**CITY OF TEMPE
DEVELOPMENT REVIEW COMMISSION**

Meeting Date: 06/23/2015
Agenda Item: 3

ACTION: Request for an Amended Planned Area Development Overlay and a Development Plan Review consisting of a new mixed-use development containing 273 apartment units, 4,500 square feet of retail space, and 1,130 square feet of office space within four live-work units within a five-story, 69'-6" high building for SOUTHBANK LOT 1, located at 1200 East Rio Salado Parkway. The applicant is Huellmantel & Affiliates.

BACKGROUND INFORMATION: SOUTHBANK LOT 1 (PL150102) is a mixed-use project proposed within the Southbank development formerly known as The Pier at Town Lake. The building is five stories high (six including mezzanine) and 98,441 total square feet in area. The request includes the following:

3RD AMENDED PLANNED AREA DEVELOPMENT OVERLAY FOR SOUTHBANK LOT1 SITE PLAN

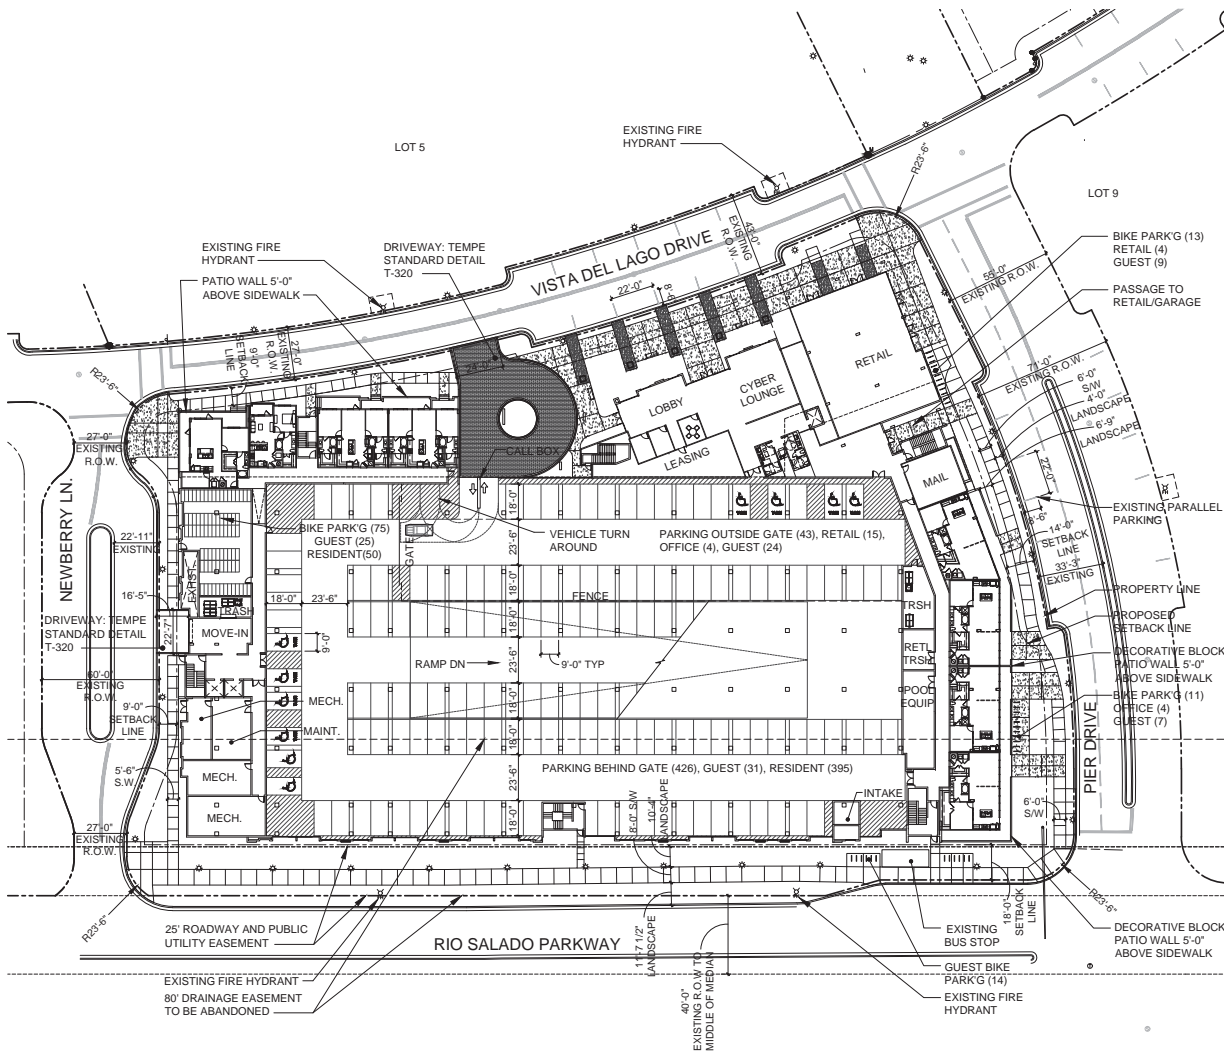
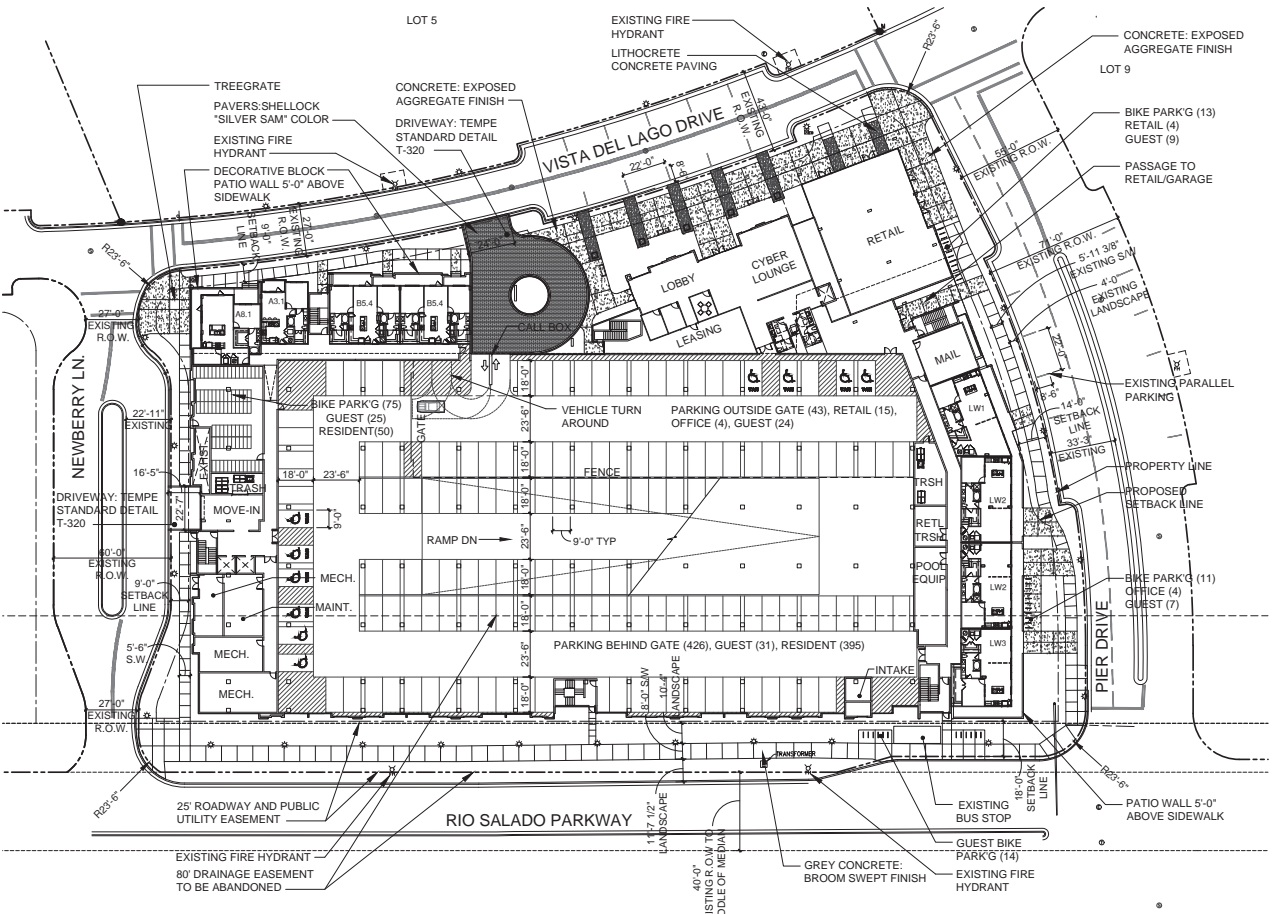
8. The PAD cover sheet and site plan shall be corrected to indicate 141 one-bedroom units instead of 140.
9. The eastern ground floor frontage of the building shall be entirely designed to accommodate commercial/retail use and live-work that provides clearly delineated floor space for commercial use.

6. Relocate the bike racks west of the bus shelter near the main entry on Vista del Lago Drive to allow the existing planter and trash can to remain and provide racks near the main entrance to the building.

project #: JL8006
 scale: 1" = 20'-0"
 issued for: Submittal
 drawn by: TEAM
 date: 04/17/2015
 drawing: Landscape Plan - pool level

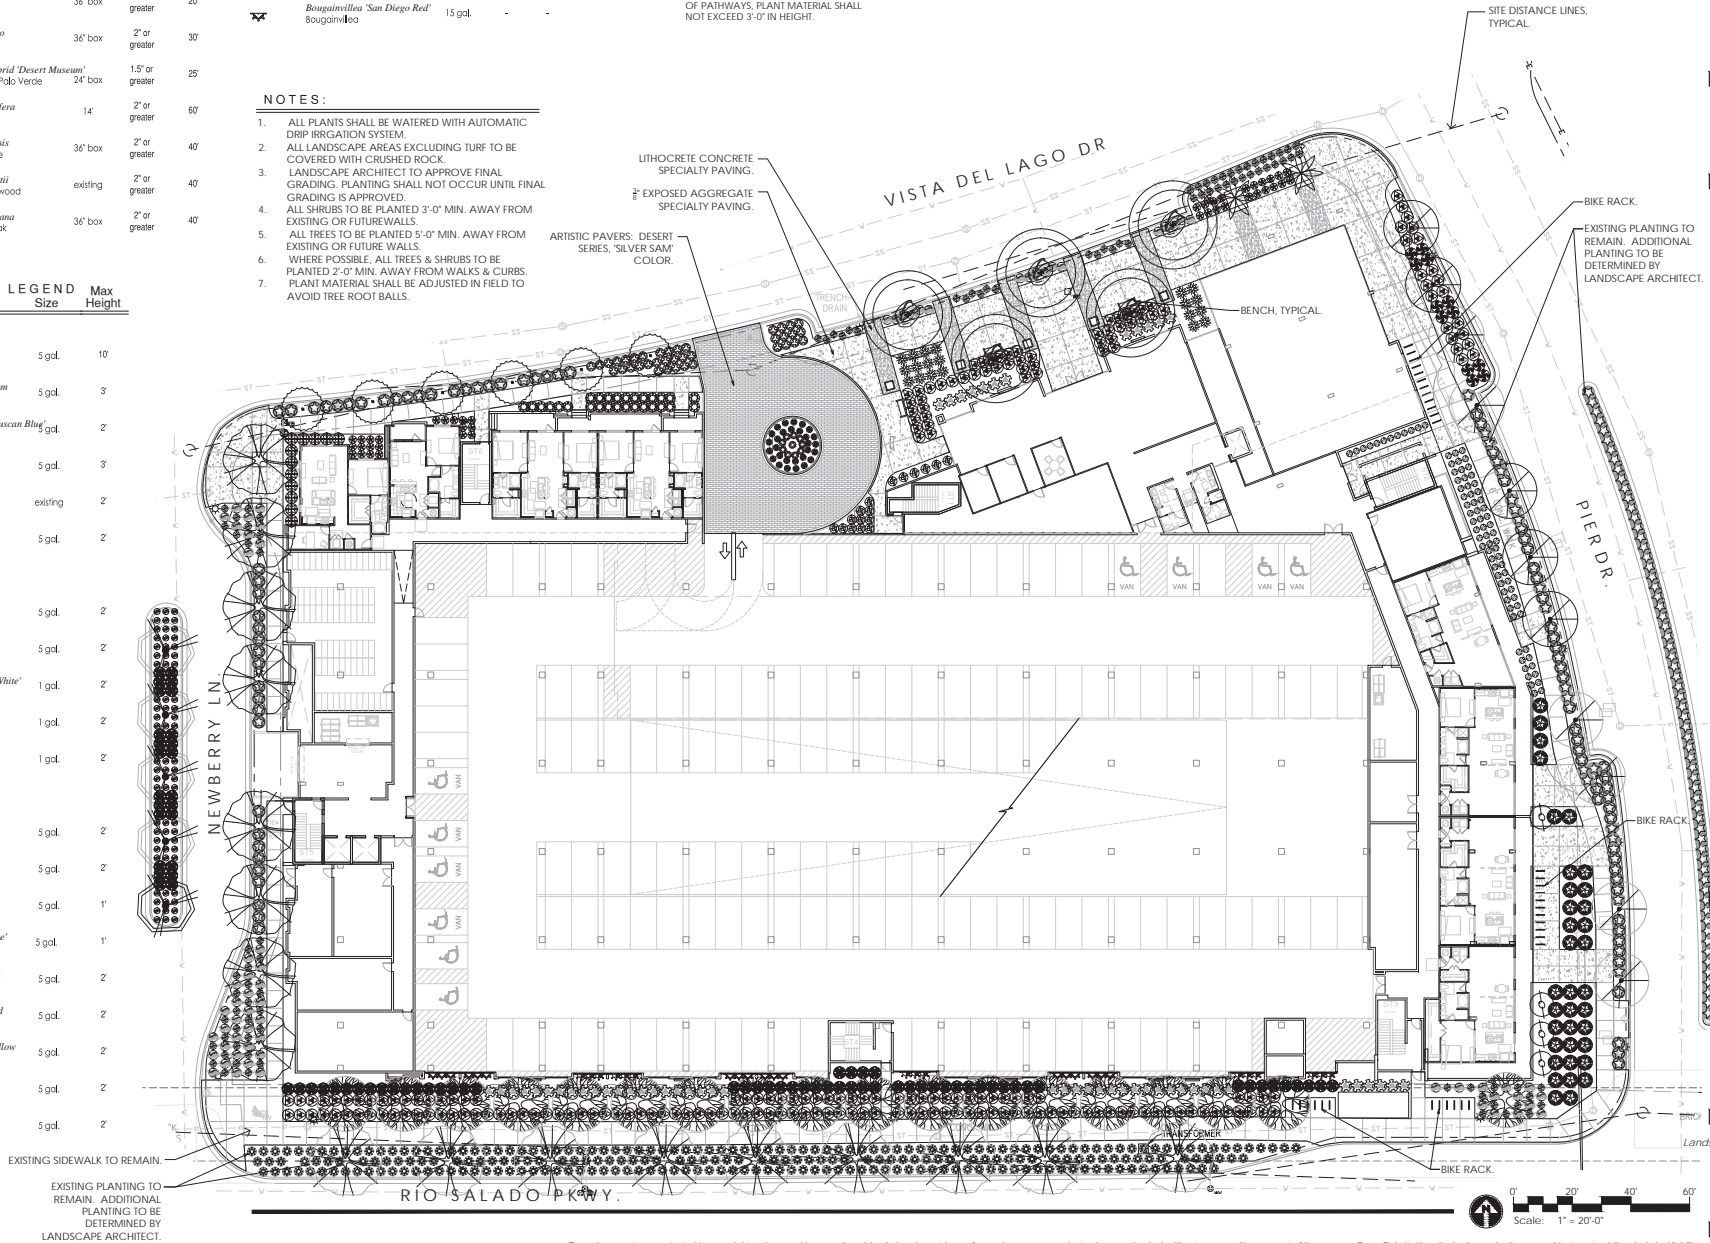
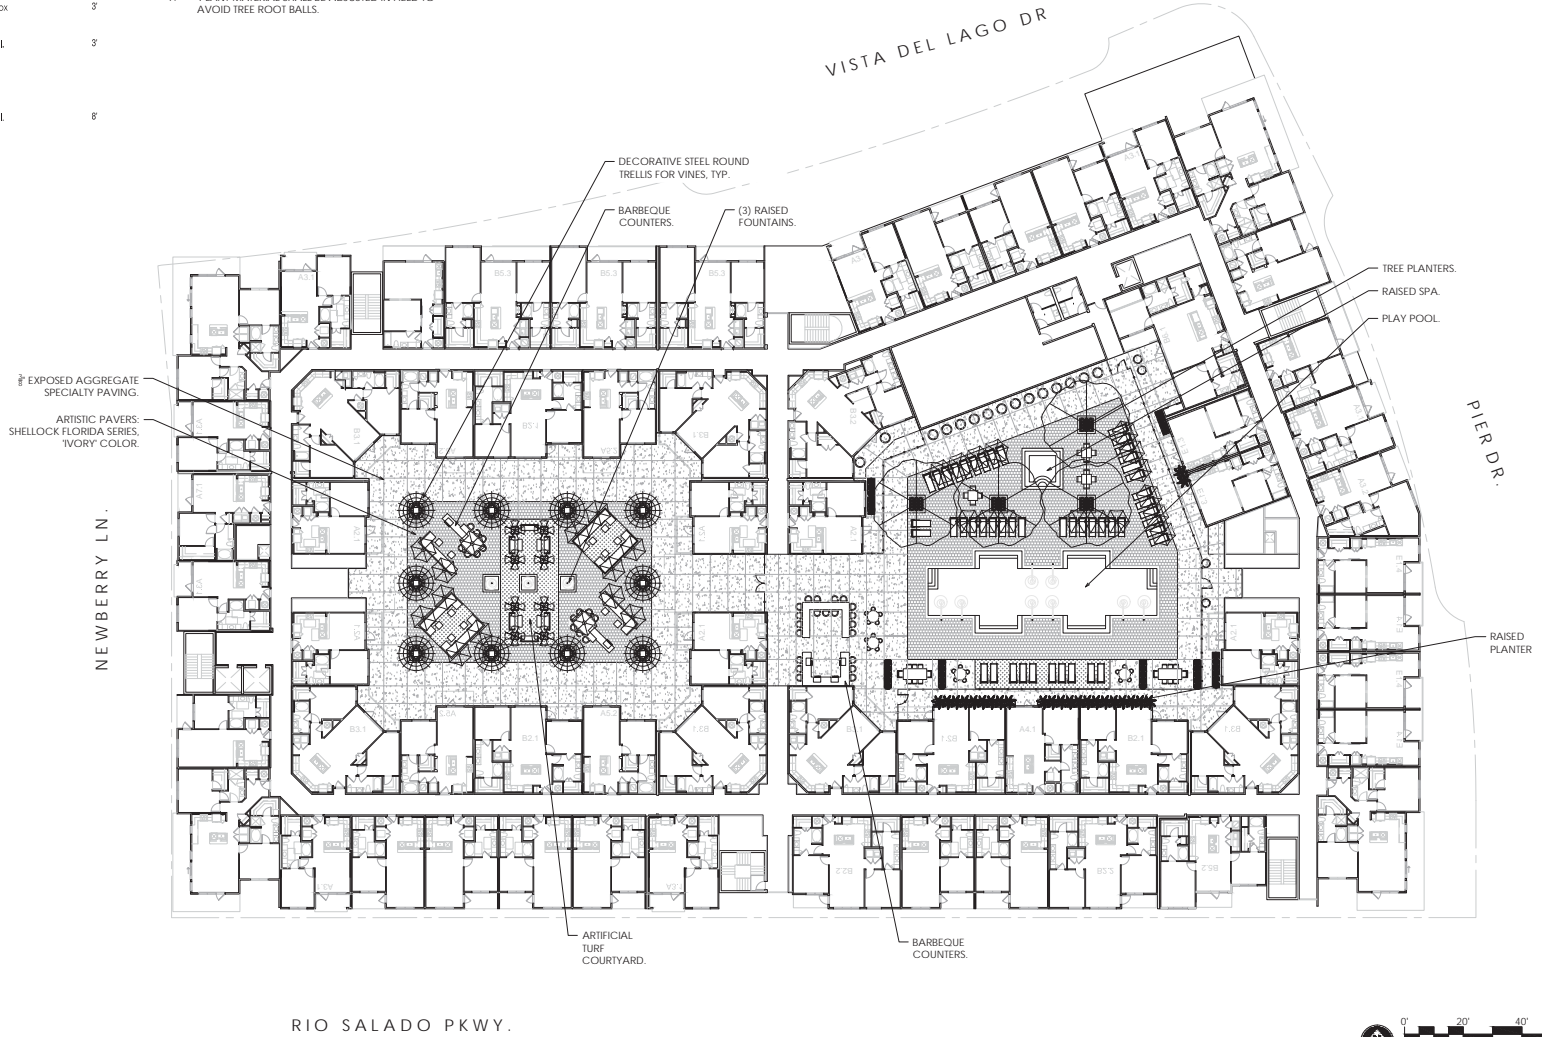
The proposed tree types along Newberry Lane and Vista del Lago Drive are not consistent with the original streetscape plan. A stipulation is included to require Desert Museum Palo Verde trees along Newberry Lane for consistency of street trees at this entry to the development. Due to the requested reduction of the north building setback, there is inadequate room for full canopy growth of the originally approved Fan-Tex Ash trees along the entire length of Vista del Lago Drive; these have been replaced with Mulga Acacias near the west end and Chinese Pistache near the east end. A condition is included to replace the proposed Chinese Pistache and the three eastern-most Mulga Acacia trees directly adjacent to Vista del Lago with Fan-Tex Ash; this will keep the streetscape somewhat consistent with the approved landscape plans for the PAD.

27. Replace the proposed Southern Live Oak trees along Newberry Lane with 36" box size Desert Museum Palo Verde trees.
28. Replace the three Chinese Pistache and three eastern-most Mulga Acacia trees adjacent to Vista del Lago Drive with minimum 1.5" caliper and 36" box size Fan-Tex Ash trees.
